Final Safety Evaluation Report

Related to Certification of the
AP1000 Standard Design

Volume 3

U.S. Nuclear Regulatory Commission
Office of Nuclear Reactor Regulation

Figure 21.A-1:
AP600 Peak Cladding Temperature Transient for the AP600 $C_D = 0.8$ DECLG Break

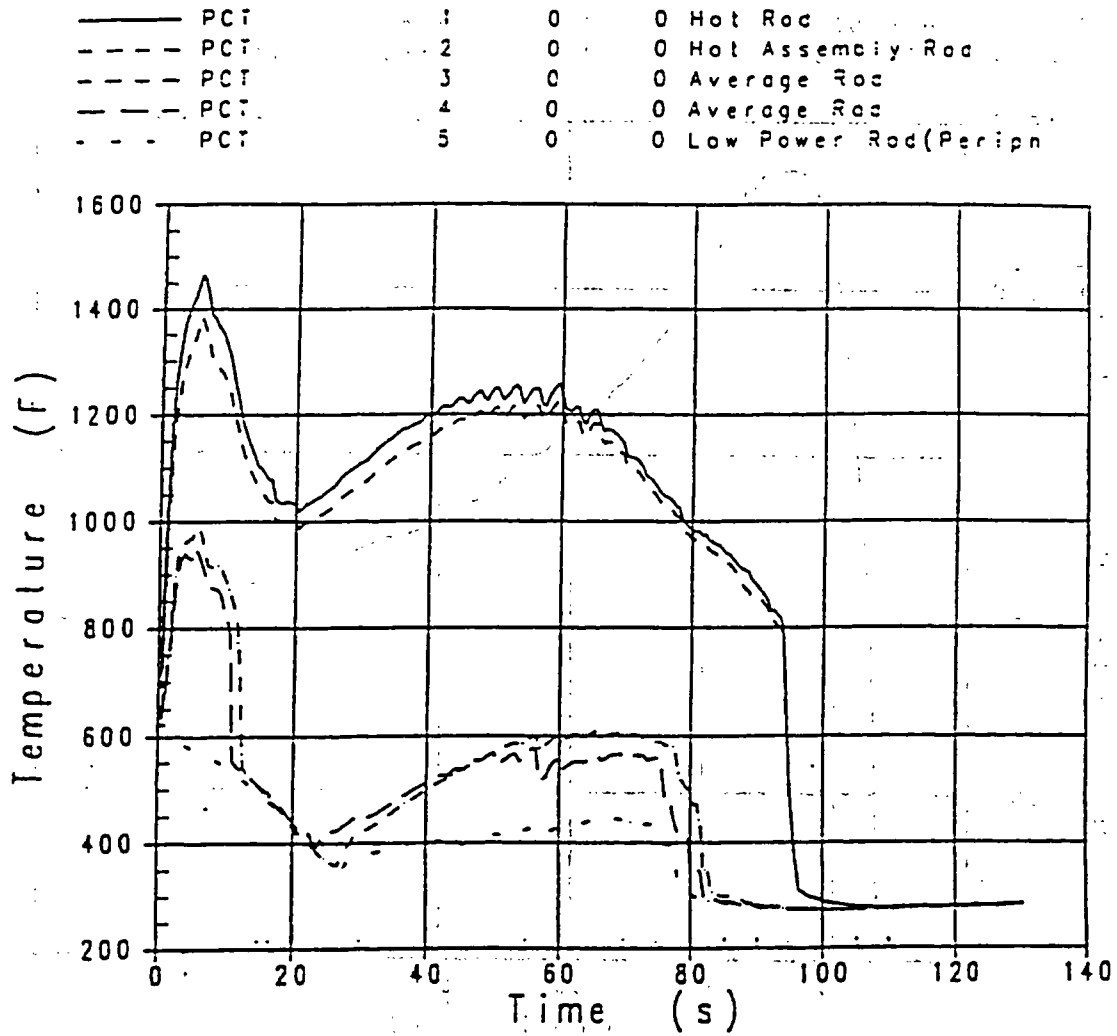
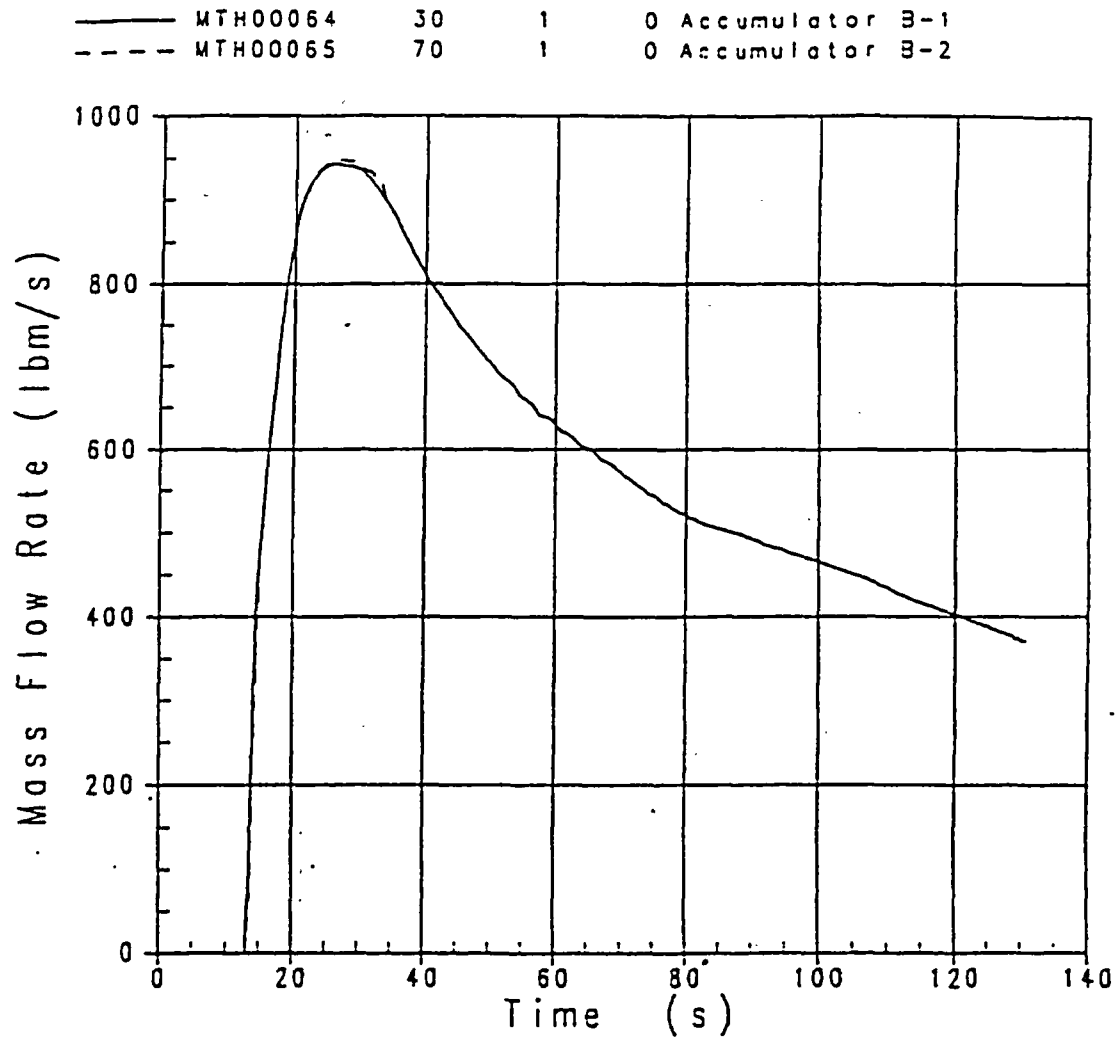
For the AP600, accumulator nitrogen cover gas was not important because the AP600 accumulators do not empty until after the core is completely quenched (see Figures 21.A-1 and 21.A-2 of this report). In addition, on the basis of the applicant's response to comment 1(g) in the letter (NSD-NRC-97-5171) dated June 10, 1997, 60 percent of the initial liquid remains in the accumulators at the time of PCT, so small changes in the analysis results or the AP600 design will not cause the accumulators to empty before the time of PCT. In the approved methodology, the applicant results presented in response to Volume 1, Question 134, of its letter (NTD-NSA-MYY-95-12) dated April 21, 1995, discussed the effects of dissolved nitrogen coming out of solution in the primary system, and the applicant showed that effect was negligible.

Figure 21.A-3
CCTF Run 58, Medium-Powered Rod, Clad Temperature Comparison at 6 ft

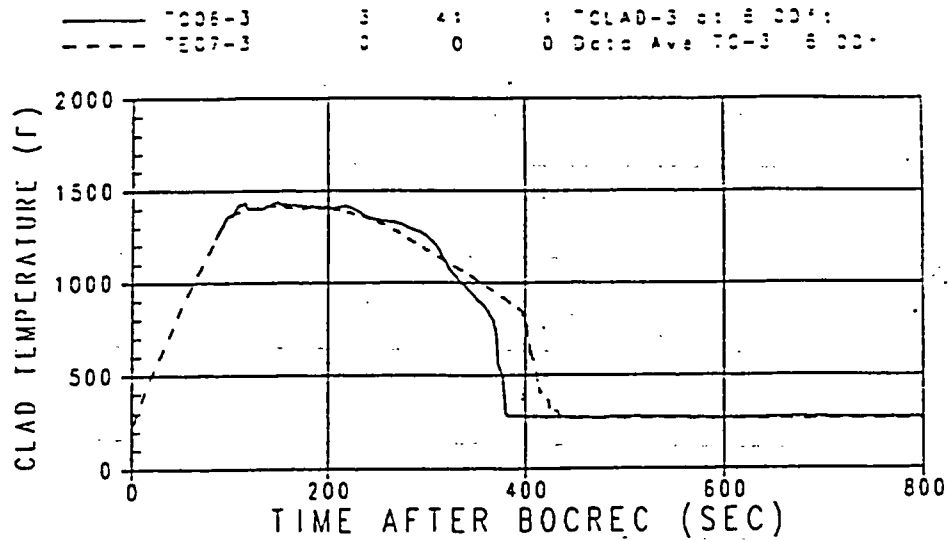
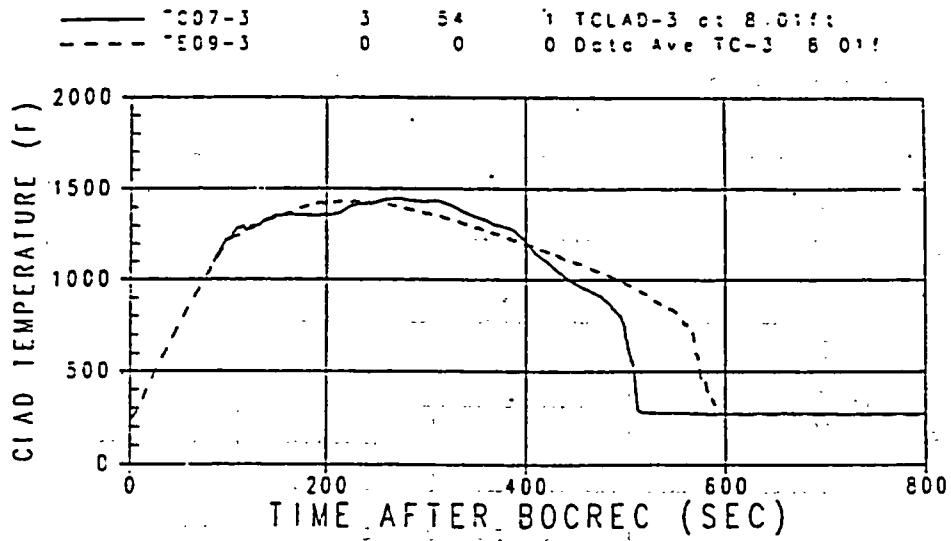
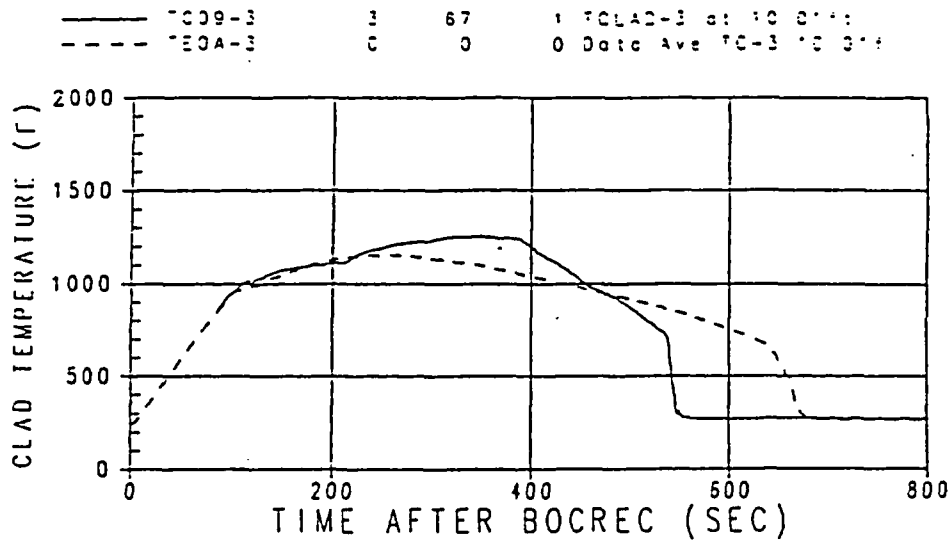
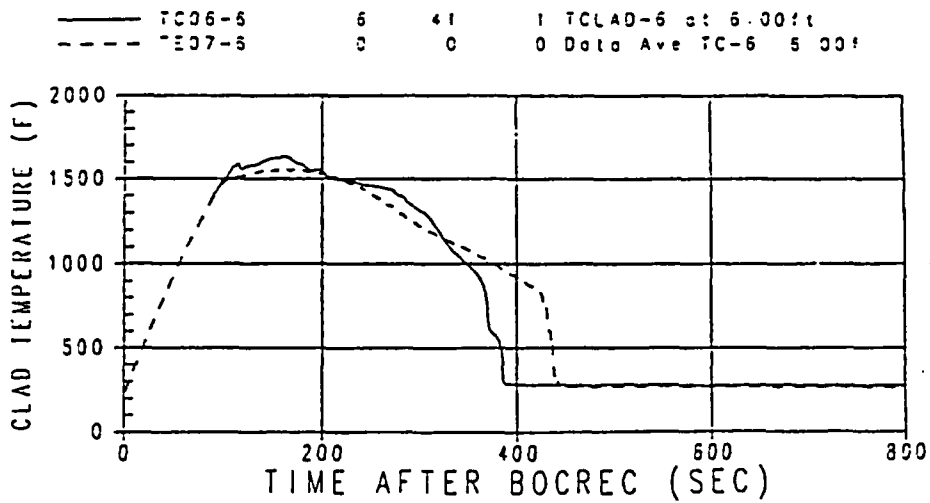
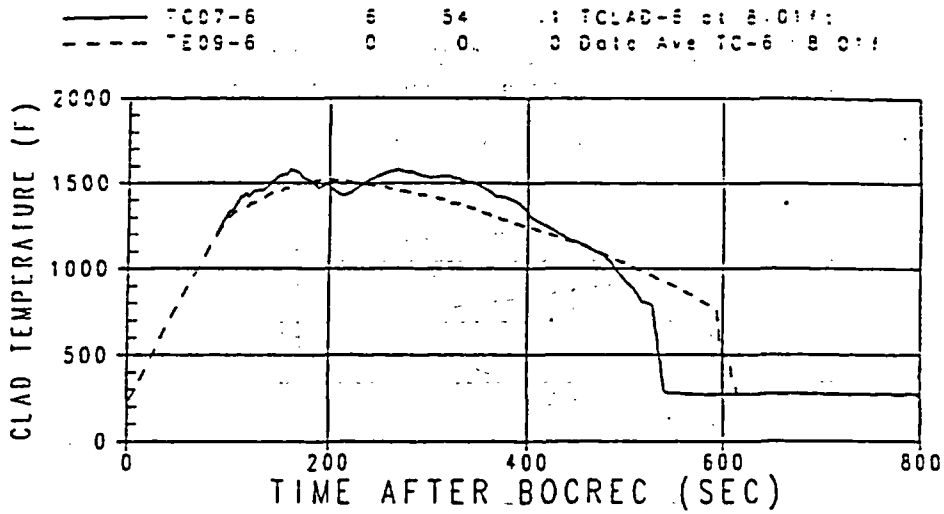
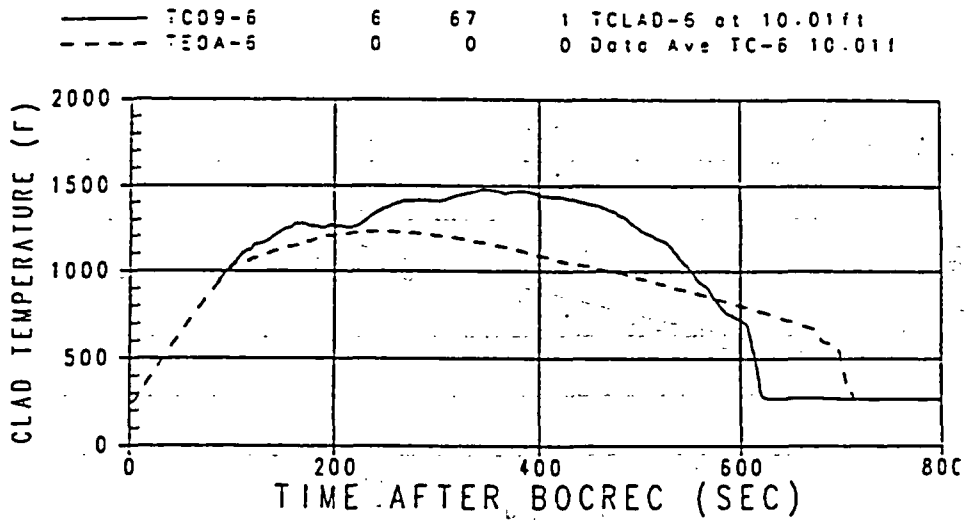
The applicant compared the calculated and measured results for a number of parameters. The cladding temperature response is illustrated in Figures 21.A-3 to 21.A-8 of this report. All the

comparisons of cladding temperature response are found in Figures 3.1-16 to -30 of WCAP-14171. The comparisons showed that the calculated results overpredicted the cladding temperatures, with the greatest overprediction coming at the 2.4 m (8 ft) and 3 m (10 ft) elevations. While the cladding PCTs were higher, the calculated cooldown after the PCT was more rapid, and quench times were earlier than indicated by the data (Figures 21.A-9 to 21.A-11 of this report). The applicant attributed the more rapid quench progression in the WCOBRA/TRAC analysis relative to the data to the fact that the calculated results did not show the core/downcomer oscillations observed in the test. As discussed in the applicant's response to comment 8 of its July 18, 1997 letter (NSD-NRC-97-5240), this difference was because of the calculated downcomer level stabilizing below the downcomer injection port, whereas the downcomer level recovered to submerge the port in the test. The lower downcomer level was the result of a small overprediction of entrainment out of the vessel.

Figure 21.A-12
CCTF Run 58, Upper Plenum Pressure Comparison

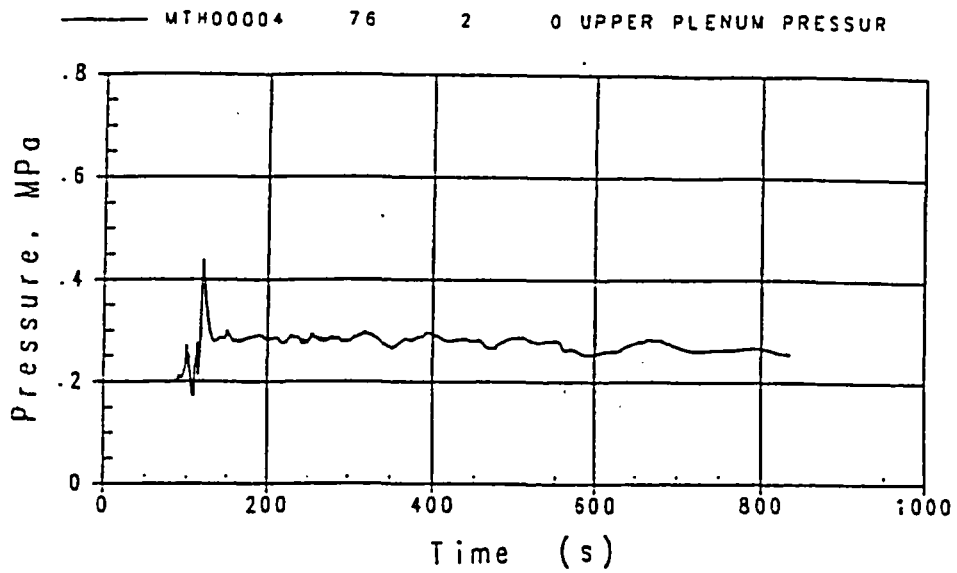
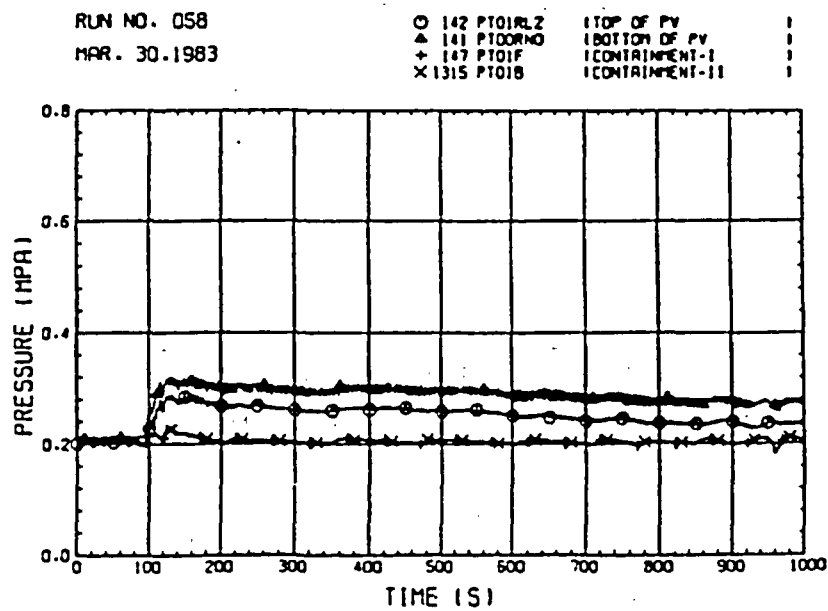
The upper plenum pressure was overpredicted for most of the test (Figure 21.A-12 of this report) because the more rapid quench advancement in the calculation resulted in higher steam production relative to the test. Downcomer and core differential pressure comparisons (Figures 21.A-13 and 21.A-14 of this report, respectively) showed that the calculated downcomer pressure difference was within the band of the oscillations observed in the test, and the measured core pressure difference was well predicted. Regarding loop flows, the comparisons showed that, in general, WCOBRA/TRAC results were relatively close to the test data except for the Cold Leg 1 and Hot Leg 4 steam mass flows, which were overpredicted (Figures 21.A-15 to 21.A-19 of this report).
